Meeting Minutes 015

State Center Community College District- West Fresno Campus

SIM-PBK Project Number: 18-14

Date and Time 09/12/2018 at 2:30 Meeting Subject CTC- AutoT ER/EP

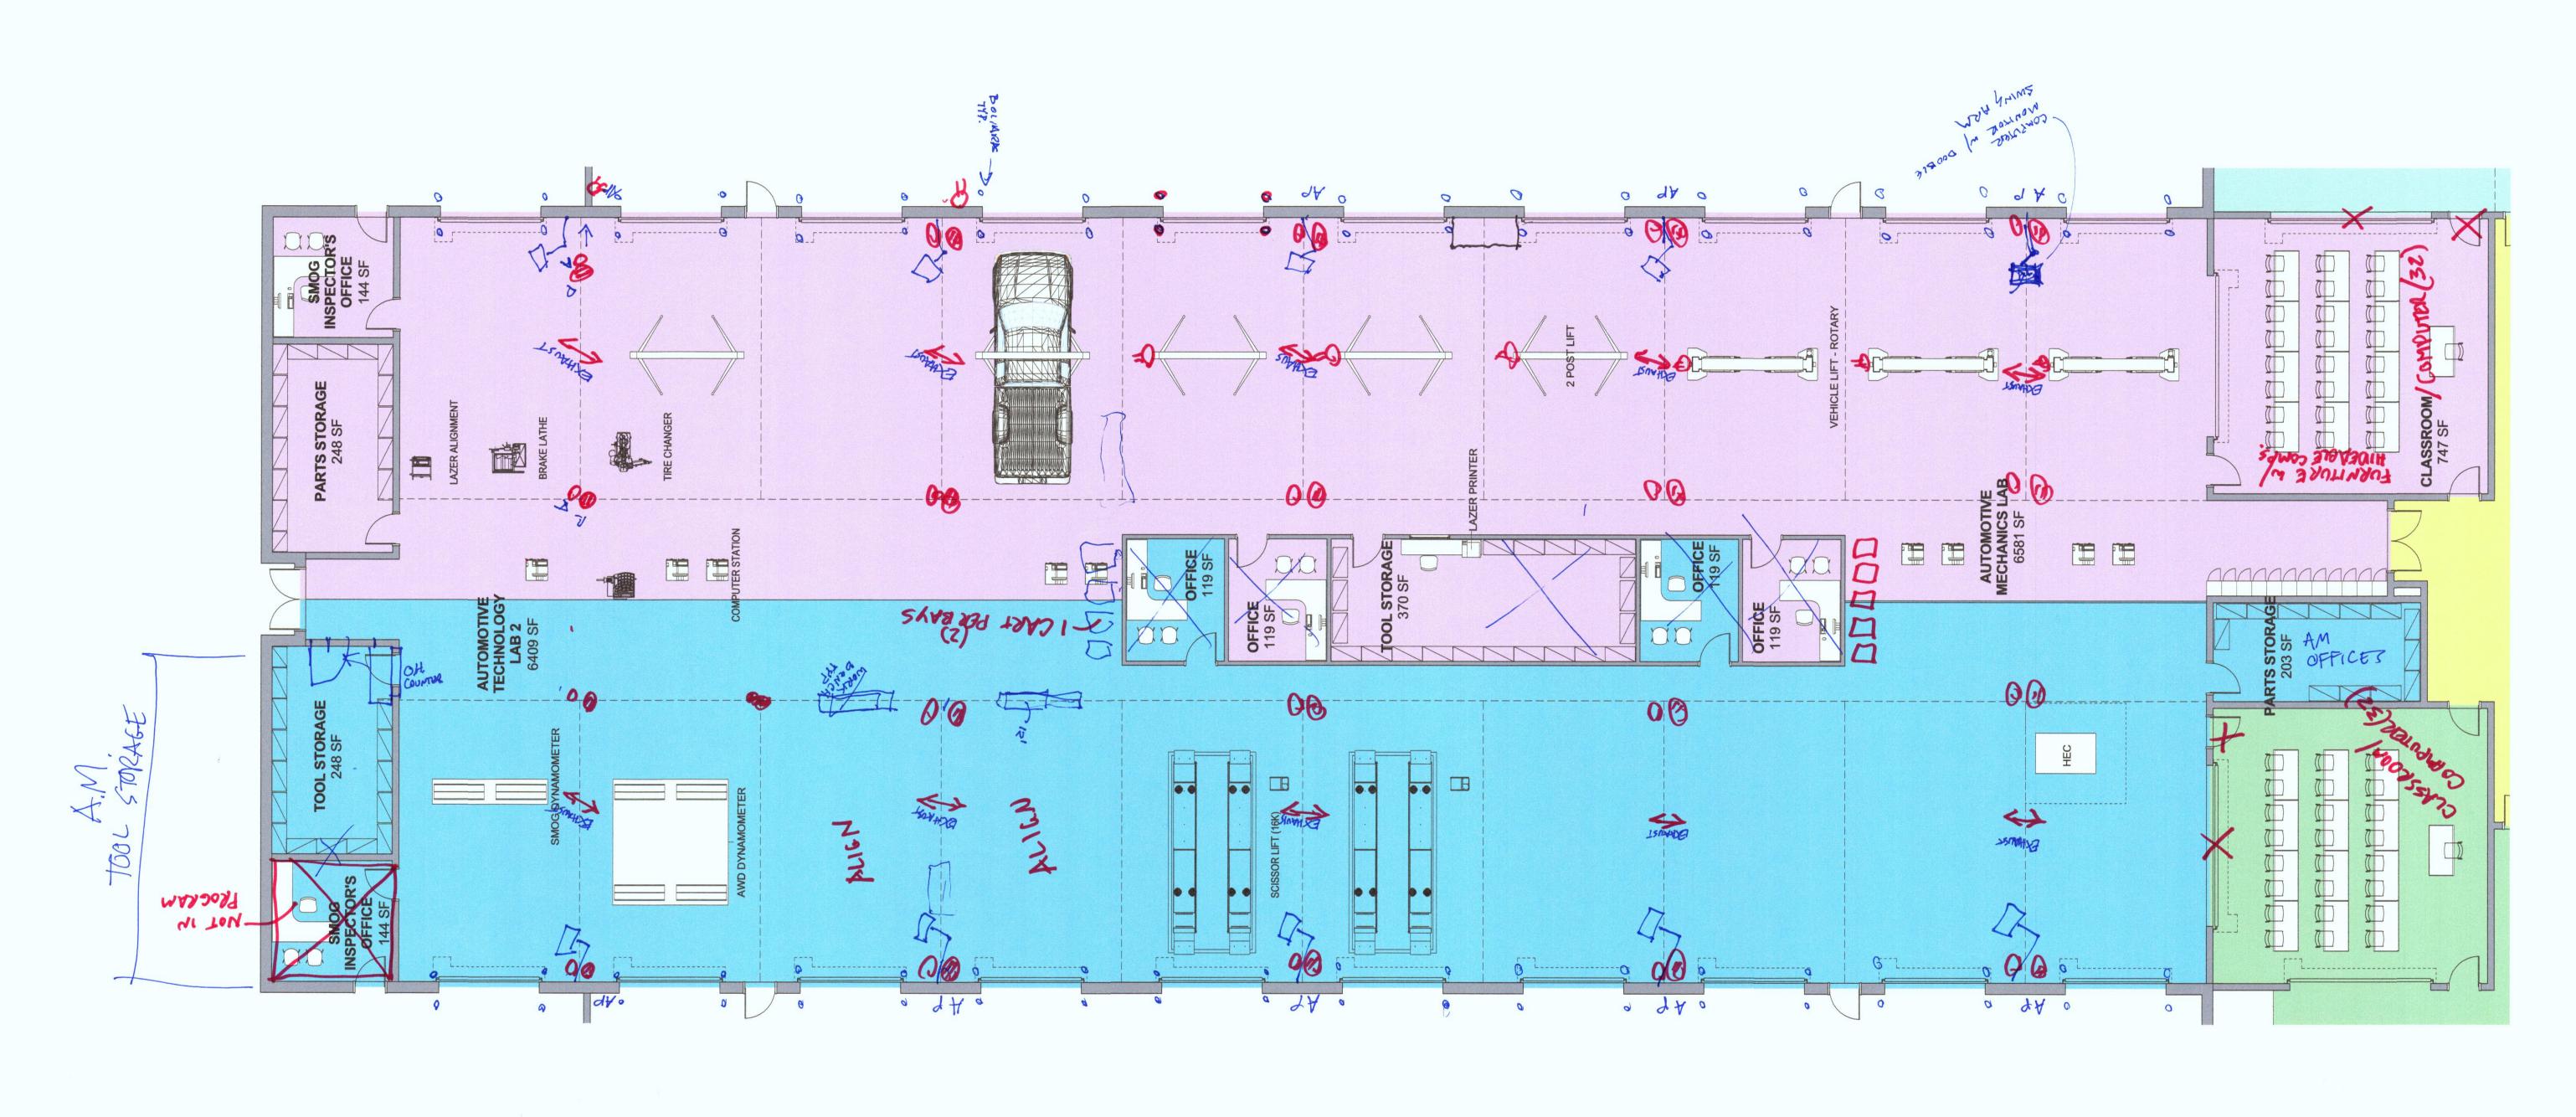
The group discussed the plan and started talking about the kind and size of needed equipment. Also, the fact that the plans need to be reduced in square footage to meet budget.

- 1) Eliminating the two classrooms at the front of the CTC building is ok as long as one of the remaining classrooms is provided with infrastructure for computer testing.

- 2) Marty would rather loose 2 auto bays than a one truck bay. Both Marty and Tim agreed to loose two car bays.
- 3) SIM-PBK to investigate using mezzanines for long-term storage

- 5) A 2'-6" x 12'-0" work bench will be needed at each bay. The best place appears to be at the head of each bay. Placing the bench here will require that the centralized storage and offices are moved. This will be less convenient in some ways but overall will serve the purposes of the program better.

- 6) Provide a rollup counter pass thru door with a counter on the inside of the storage room, to help with passing out tools to students.
- 7) Could the smog inspector be eliminated from the program?

- 8) All additional notes are on the attached markup.

EXHAUST PER 2 (BAYS)
